ADDENDUM NUMBER 1

PROJECT: Replace Roof, Mullen Building
2009-069M21

DATE: 06/29/22

OWNER: Trinidad State College
600 Prospect St
Trinidad, CO 81082

SHEET NO.:
A1.01

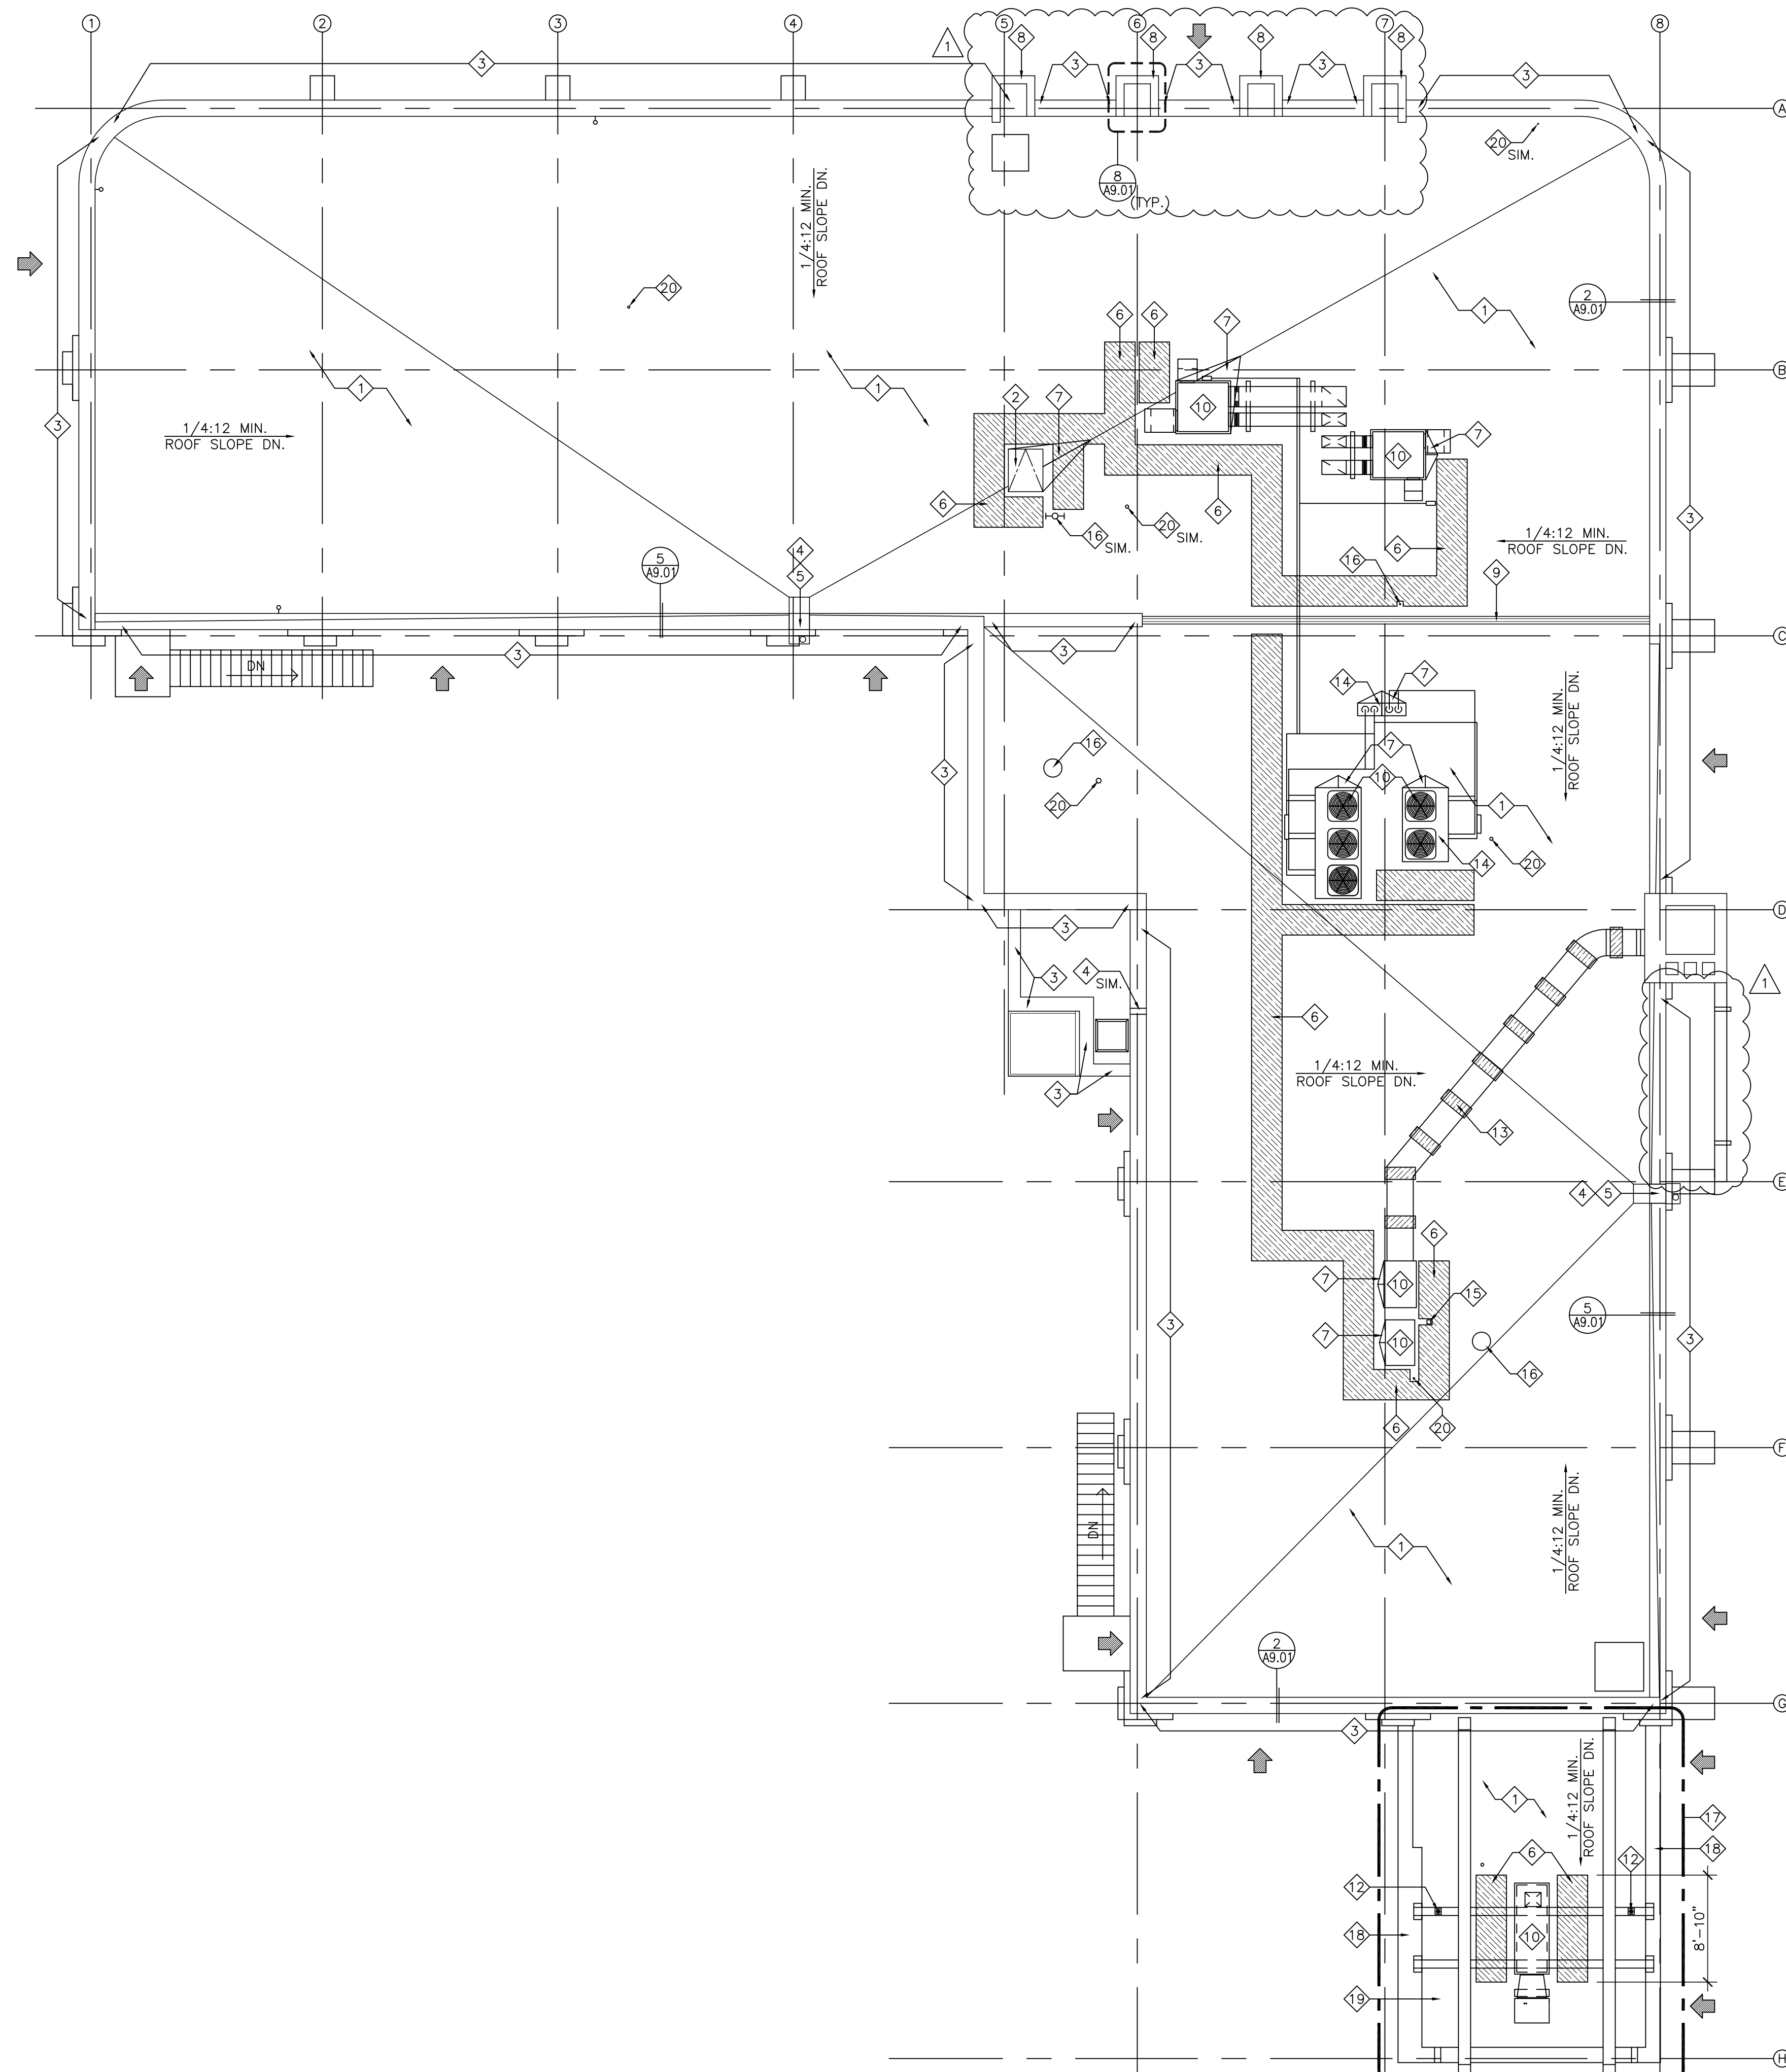
1. Q: Please confirm that current roof assembly to be removed.
A: We confirm that existing roof assembly is to be removed per key note 1 on roof demolition plan A1.01. See response to Question 10 below for more information.

6. Q: Alternate # 2, can you confirm that it is one (1) lower roof that will need to be replaced? Second roof on East side does not exist
A: The eastern lower roof has been removed from the project. See the attached sheets A1.01 & A1.02 revised 6/29/22.

13. Q: Are the collector heads and downspouts to be replaced at the scuppers or are they to remain?
A: The conductor heads and downspouts are existing to remain per key note 19 on sheet A1.01.

2 (E) PARAPET CAP FLASHING
A9.01 SCALE: 1-1/2" = 1'-0"

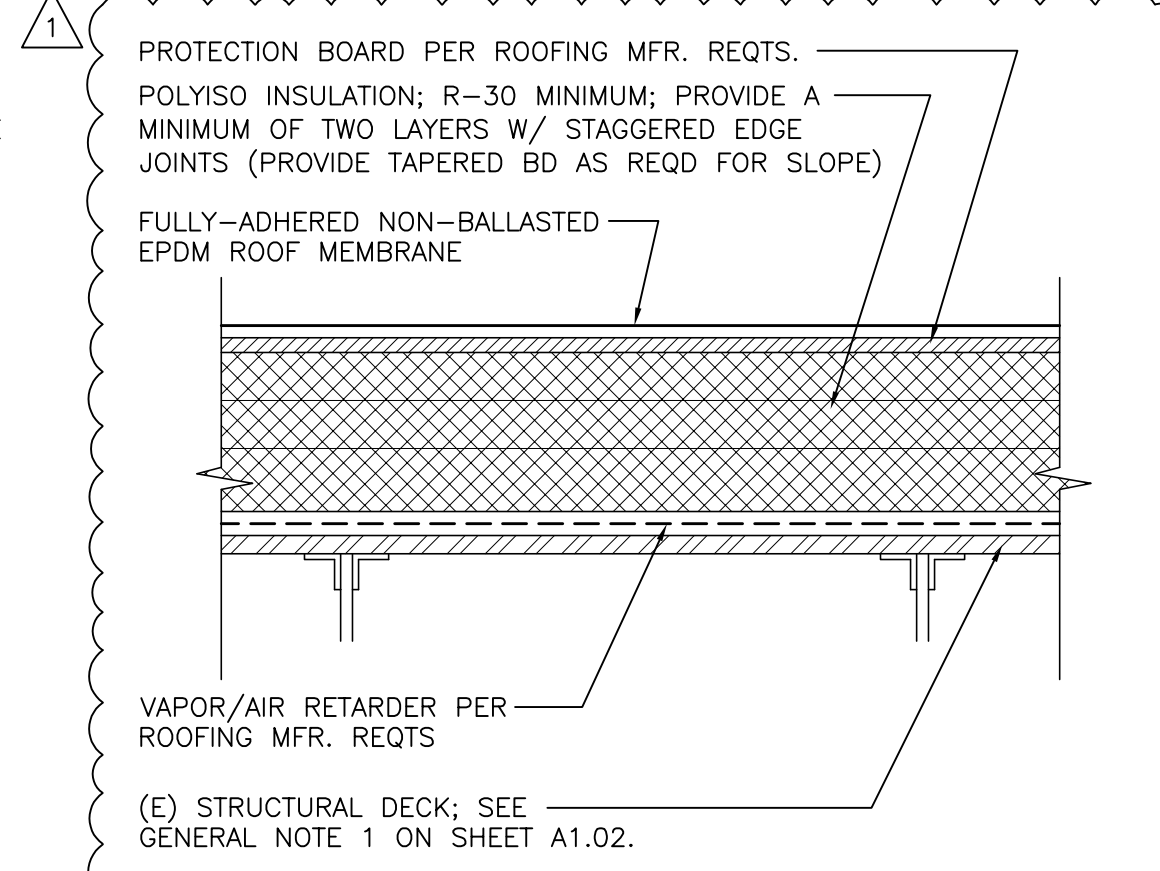
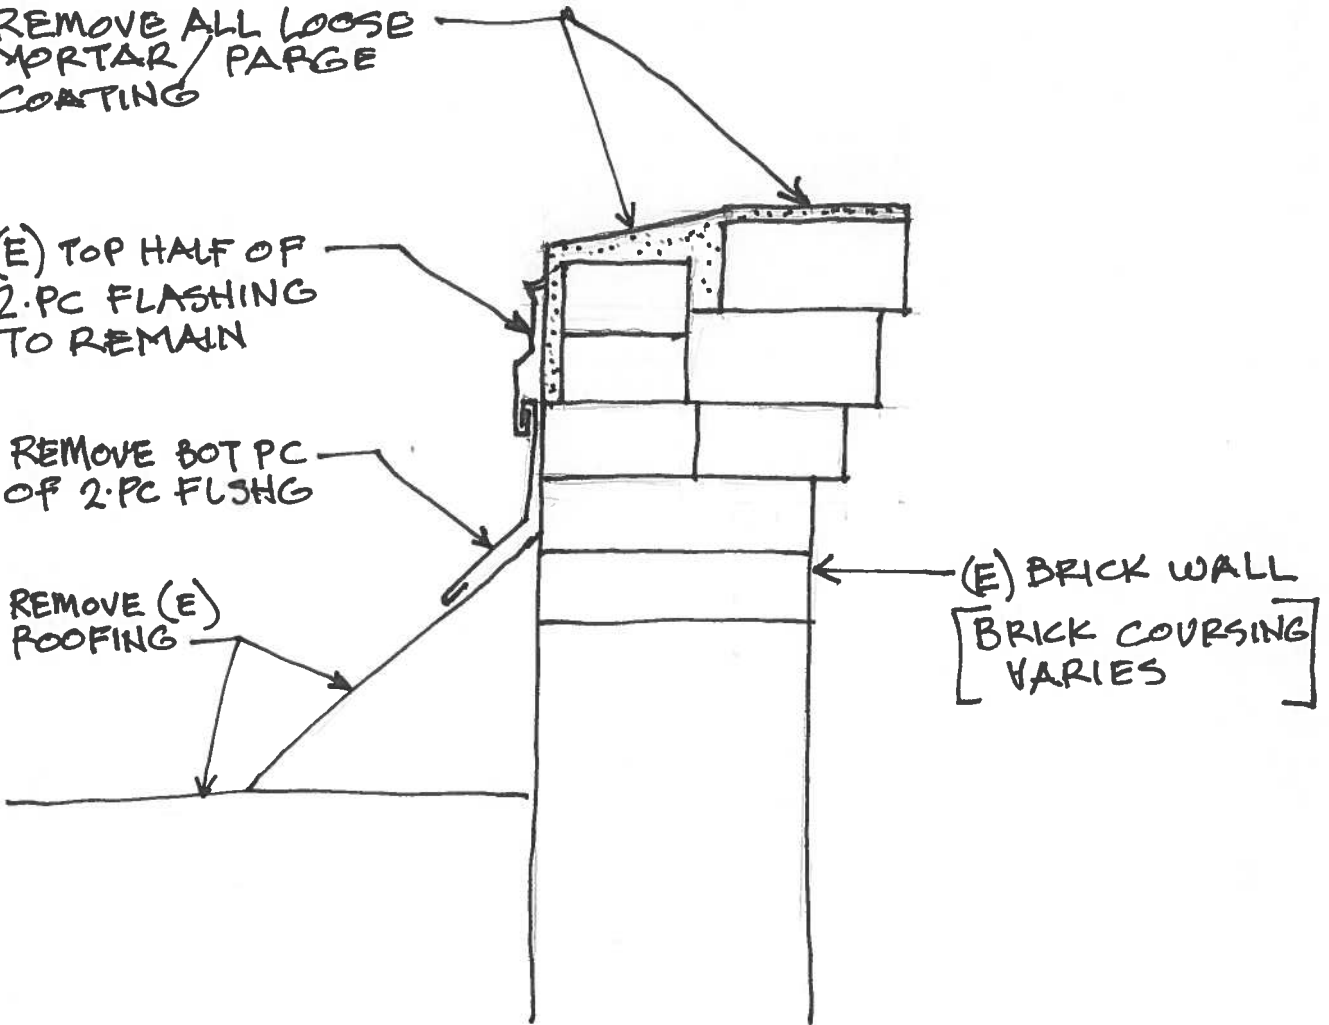
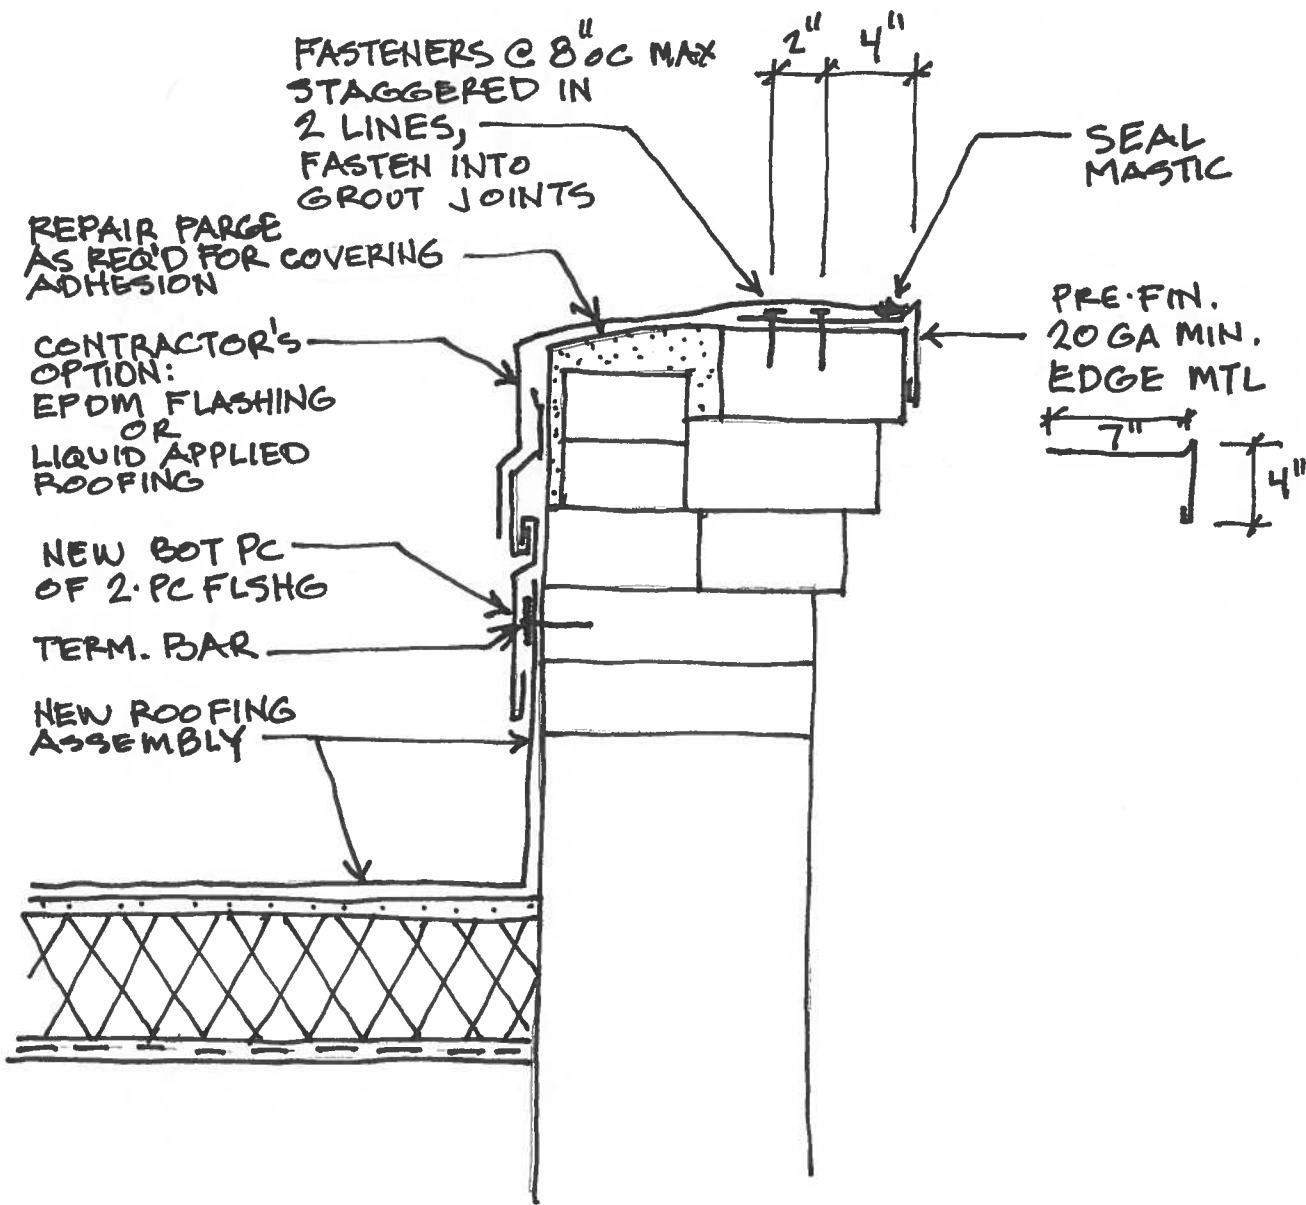
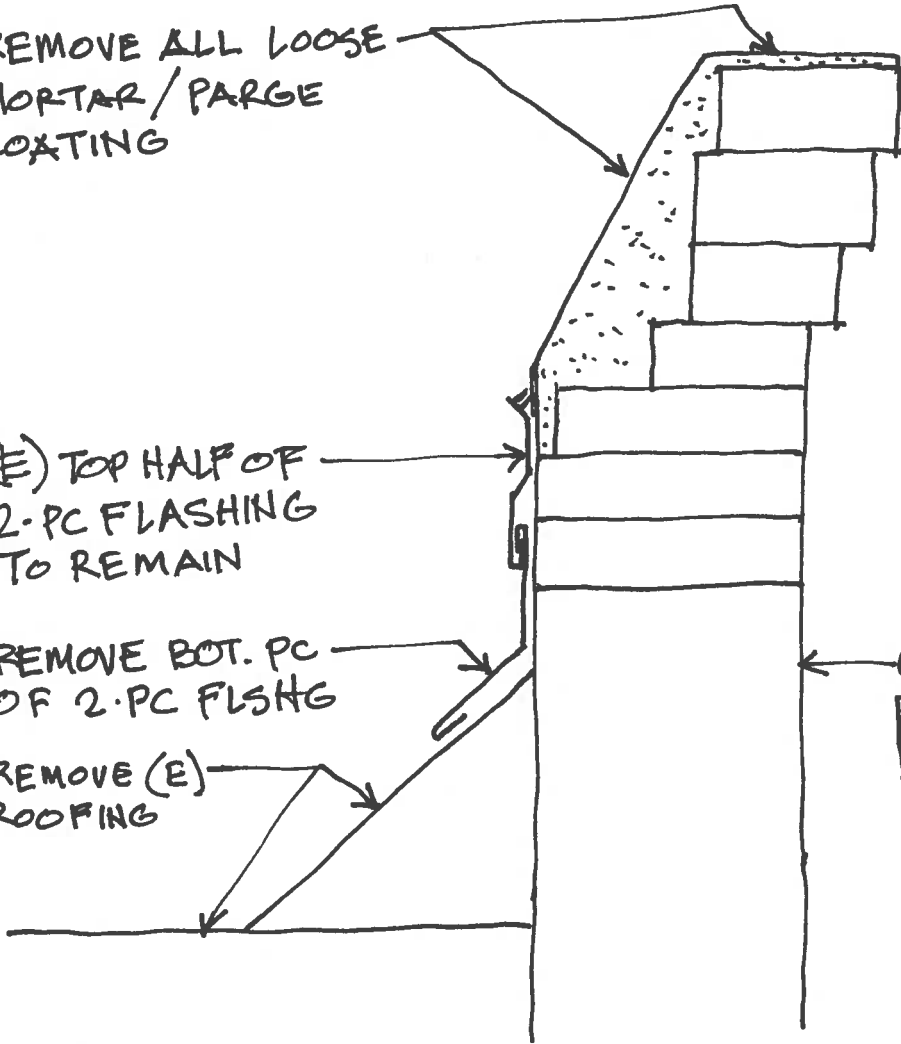
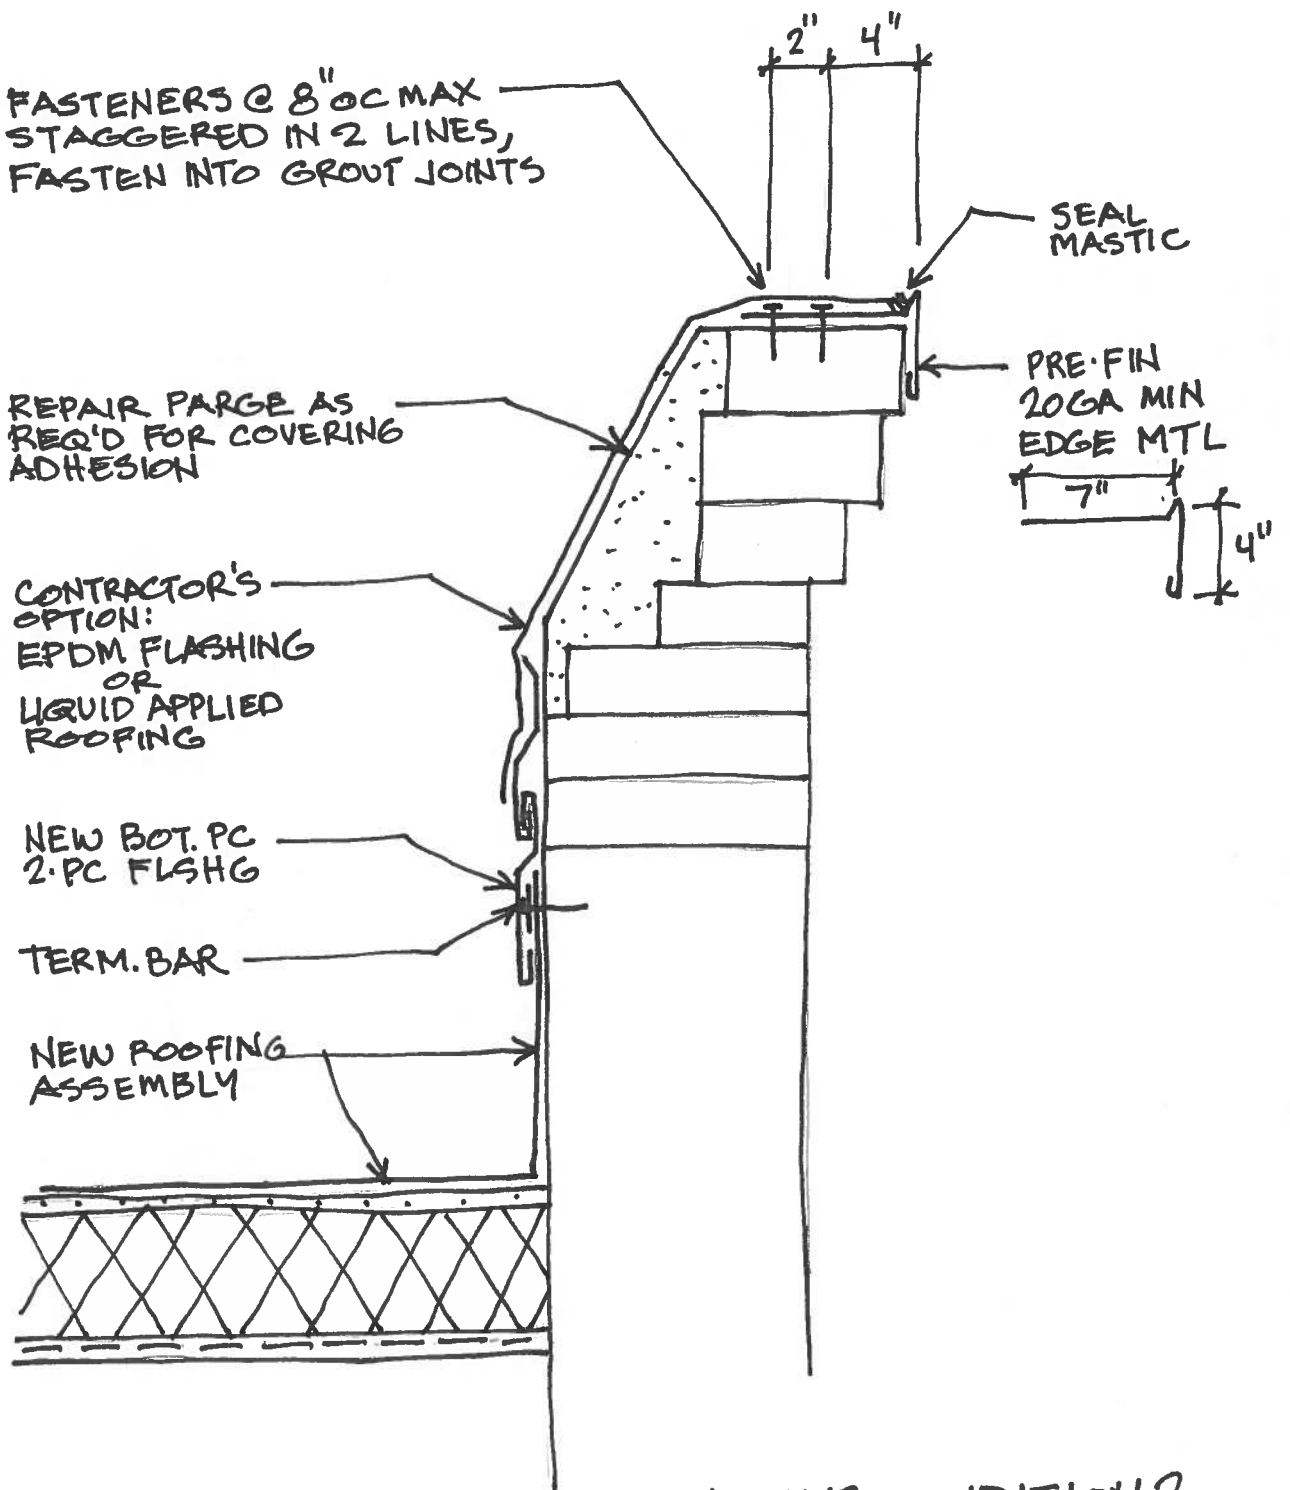
14. Q: Please confirm that the asbestos is only to be found in the wall flashings and not the entire roof.
A: See response to question #3 above.
15. Q: What is the new detail for the parapet with the mortar?
A: See attached revised details SK-1, SK-2, SK-3 & SK-4. They replace details 2/A9.01 and 5/A9.01

G0.00, A1.01, A1.02 & A9.01
28. Revisions: Sheet A9.01, detail 2/A9.01 is to be replaced with attached drawings SK-1 & SK-2. Detail 5/A9.01 is to be replaced with attached drawings SK-3 & SK-4. (These changes have not been identified on the revised A9.01 sheet.) These SK drawings are representative of the range of parapet conditions and all similar conditions shall apply the principles of these details.
29. Additive Alternate #3 has been newly defined in this Addendum. It shall include the structural bracing and roofing work associated with the four masonry pilasters on the north side of the building. These have been identified on sheets A1.01, A1.02 & A9.01.
